Access Compliance Report Public Rights-of-Way (Curb Ramps)

Main Street: GRAMERCY_DR Cross Street: GERSHON_PL Location: SE

ADA ID: RPAT211025113128 Ramp Type: Type 1 - Perpendicular Diagonal Initial Pass/Fail: Pass Overall Compliance: No Severity Score: 26

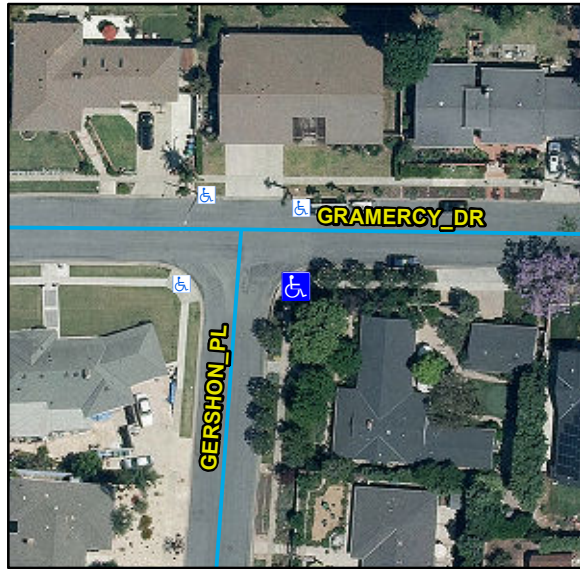
Remove & Replace Curb Ramp With Two New Directional Ramps or Equivalent. Remove & Replace Gutter.

R204.3, R304.2.1, R304.2.2-Perp, R304.3.2-Para, R304.5.3, R305, R304.5.4, STD 1115
